UNITED STATES PATENT AND TRADEMARK OFFICE

APPLICATION NO.	FILING DATE	FIRST NAMED INVENTOR	ATTORNEY DOCKET NO.	CONFIRMATION NO.
10/552,376	10/07/2005	Hua Chen	H0003955	9276
46507 7590 03/05/2009 HONEYWELL TURBO TECHNOLOGIES 3201 WEST LOMITA BOULEVARD (LAW DEPARTMENT) TORRANCE, CA 90505				
EXAMINER VERDIER, CHRISTOPHER M				
ART UNIT 3745		PAPER NUMBER		
MAIL DATE 03/05/2009		DELIVERY MODE PAPER

Office Action Summary

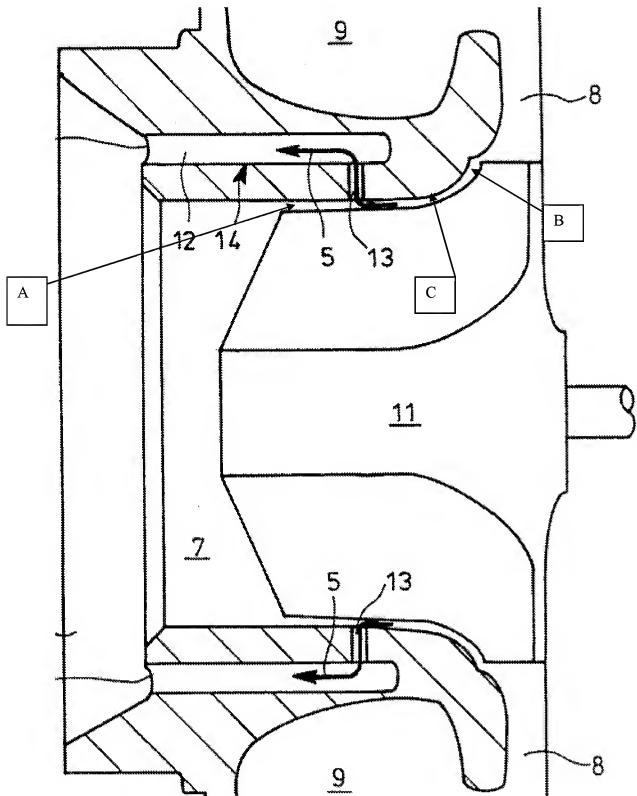
Claims 1, 15/1, and 18 are rejected under 35 U.S.C. 102(b) as being anticipated by Mitsubori 5,246,335 (figure 2). Disclosed is a compressor comprising a compressor wheel having a hub 11, unnumbered free-ended compressor blades and being mounted for rotation on an unnumbered shaft, each blade being characterized by a free-ended outer edge, an upstream leading edge and a downstream trailing edge, and a shroud 4 mounted adjacent and around the outer edges of the compressor blades and defining a gas flow path between the shroud and the hub from a compressor inlet 6 to a diffuser outlet 8, through which the blades rotate with respect

to the shroud, wherein in cross-section the shroud forms a surface A along the flow path, the surface being characterized by a profile that includes a relative discontinuity B in the region of the trailing edge, wherein the discontinuity forms a downstream-facing blocking face adapted to impede an upstream flow of gas between the shroud and the wheel, the blocking face extending across the flow path to form a sharp edge connecting the blocking face to a smoothly curving surface C along the gas flow path upstream of the discontinuity. The compressor is included with a turbocharger. The discontinuity is in the form of a groove. Note the annotated figure below.

FIG. 4

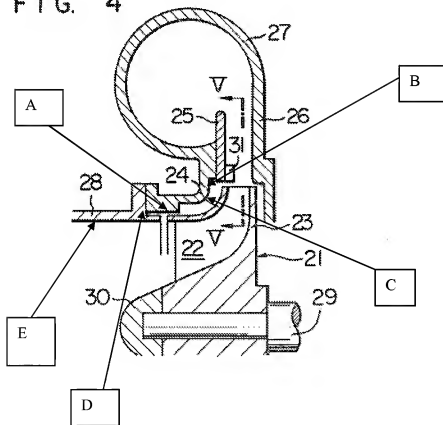
Claims 1, 4, 5, 6, 9, 11, 12/6, 13/6, 14/6, 15/6, 12/9, 13/9, 14/9, 12/4, 13/4, 14/4, 15/1, 15/4, 15/11, and 18 are rejected under 35 U.S.C. 103(a) as being unpatentable over Yoshinaga 4,395,197 in view of Jones 3,893,787. Yoshinaga disclosed a compressor substantially as claimed, comprising a compressor wheel 21 having a hub 1, compressor blades 22 and being mounted for rotation on a shaft 29, each blade being characterized by an outer edge, an upstream leading edge and a downstream trailing edge, and a shroud 27/28 mounted adjacent (note that adjacent does not require that two elements be immediately next to one another) and around the outer edges of the compressor blades and defining a gas flow path between the shroud and the hub from a compressor inlet to a diffuser outlet, through which the blades rotate with respect to the shroud, wherein in cross-section the shroud forms a surface A along the flow path, the surface being characterized by a profile that includes a relative discontinuity B in the region of the trailing edge, wherein the discontinuity forms a downstream-facing blocking face adapted to impede an upstream flow of gas between the shroud and the wheel, the blocking face extending across the flow path to form a sharp edge connecting the blocking face to a smoothly curving

surface C along the gas flow path upstream of the discontinuity. The cross-section profile of the shroud surface along the flow path is further characterized by a second relative discontinuity D that is in the region of the leading edge, wherein the second relative discontinuity forms a second downstream-facing blocking face adapted to impede an upstream flow of gas between the shroud and the wheel, the second blocking face extending across the flow path to form a sharp edge connecting the second blocking face to a second smooth surface E upstream of the second discontinuity. The second discontinuity is located upstream of the leading edge of the wheel blades. The second discontinuity is spaced from the leading edge of the wheel blades by a distance of the same order as the axial clearance of the trailing edge from the compressor housing. The or each downstream-facing blocking face comprises a planar surface cut into the curving surface. The second downstream-facing blocking face comprises a planar surface cut into the curving surface, and the planar surface is perpendicular to the axis of the shaft. The radial extent of the second discontinuity is of the same order as the radial clearance between the trailing edge and the housing. The sizes of the first and second discontinuities are closely similar. The discontinuity is in the form of a groove. The shapes of the first and second discontinuities are closely similar. Concerning claim 15, the term “turbocharger” is recited in the preamble of the claim and has not been given patentable weight. A preamble is generally not accorded any patentable weight where it merely recites the purpose of a process or the intended use of a structure, and where the body of the claim does not depend on the preamble for completeness but, instead, the process steps or structural limitations are able to stand alone. See *In re Hirao*, 535 F.2d 67, 190 USPQ 15 (CCPA 1976) and *Kropa v. Robie*, 187 F.2d 150, 152, 88 USPQ 478, 481 (CCPA 1951). Note the annotated figure below.

However, Yoshinaga does not disclose that the compressor blades are free-ended, with each blade having a free-ended outer edge (claim 1). Rather, the compressor blades have a shroud 24.

It would have been obvious at the time the invention was made to a person having ordinary skill in the art to remove the shroud from the compressor wheel of Yoshinaga such that the compressor blades are free-ended, with each blade having a free-ended outer edge, as taught by Jones, for the purpose of reducing rotating mass of the compressor wheel.

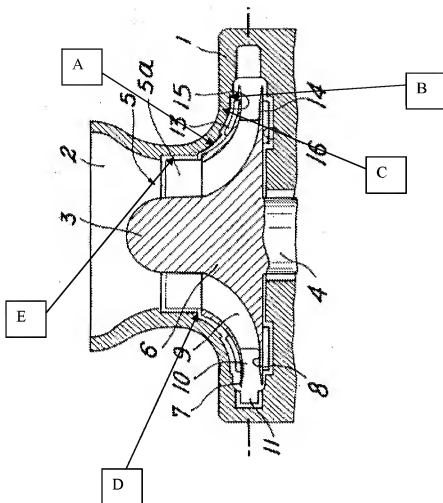
Claims 1, 4, 5, 9, 11, 13/9, 14/9, 13/4, 14/4, 15/1, 15/4, 15/11, and 18 are rejected under 35 U.S.C. 103(a) as being unpatentable over Fabri 3,824,029 in view of Jones 3,893,787. Fabri discloses a compressor substantially as claimed, comprising a compressor wheel 3/6 having a hub 3 and compressor blades 9 and being mounted for rotation on a shaft 4, each blade being characterized by an outer edge, an upstream leading edge and a downstream trailing edge, and a shroud 1 mounted adjacent (note that adjacent does not require that two elements be immediately next to one another) and around the outer edges of the compressor blades and defining a gas flow path between the shroud and the hub from a compressor inlet to a diffuser outlet, through which the blades rotate with respect to the shroud, wherein in cross-section the shroud forms a surface A along the flow path, the surface being characterized by a profile that includes a relative discontinuity B in the region of the trailing edge, wherein the discontinuity forms a downstream-

facing blocking face adapted to impede an upstream flow of gas between the shroud and the wheel, the blocking face extending across the flow path to form a sharp edge connecting the blocking face to a smoothly curving surface C along the gas flow path upstream of the discontinuity. The cross-section profile of the shroud surface along the flow path is further characterized by a second relative discontinuity D that is in the region of the leading edge, wherein the second relative discontinuity forms a second downstream-facing blocking face adapted to impede an upstream flow of gas between the shroud and the wheel, the second blocking face extending across the flow path to form a sharp edge connecting the second blocking face to a second smooth surface E upstream of the second discontinuity. The second discontinuity is located upstream of the leading edge of the wheel blades. The or each downstream-facing blocking face comprises a planar surface cut into the curving surface. The second downstream-facing blocking face comprises a planar surface cut into the curving surface, and the planar surface is perpendicular to the axis of the shaft. The sizes of the first and second discontinuities are closely similar. The shapes of the first and second discontinuities are closely similar. Concerning claim 15, the term “turbocharger” is recited in the preamble of the claim and has not been given patentable weight. A preamble is generally not accorded any patentable weight where it merely recites the purpose of a process or the intended use of a structure, and where the body of the claim does not depend on the preamble for completeness but, instead, the process steps or structural limitations are able to stand alone. See *In re Hirao*, 535 F.2d 67, 190 USPQ 15 (CCPA 1976) and *Kropa v. Robie*, 187 F.2d 150, 152, 88 USPQ 478, 481 (CCPA 1951). Note the annotated figure below.

However, Fabri does not disclose that the compressor blades are free-ended, with each blade having a free-ended outer edge (claim 1). Rather, the compressor blades have a shroud 7.

It would have been obvious at the time the invention was made to a person having ordinary skill in the art to remove the shroud from the compressor wheel of Fabri such that the compressor blades are free-ended, with each blade having a free-ended outer edge, as taught by Jones, for the purpose of reducing rotating mass of the compressor wheel.
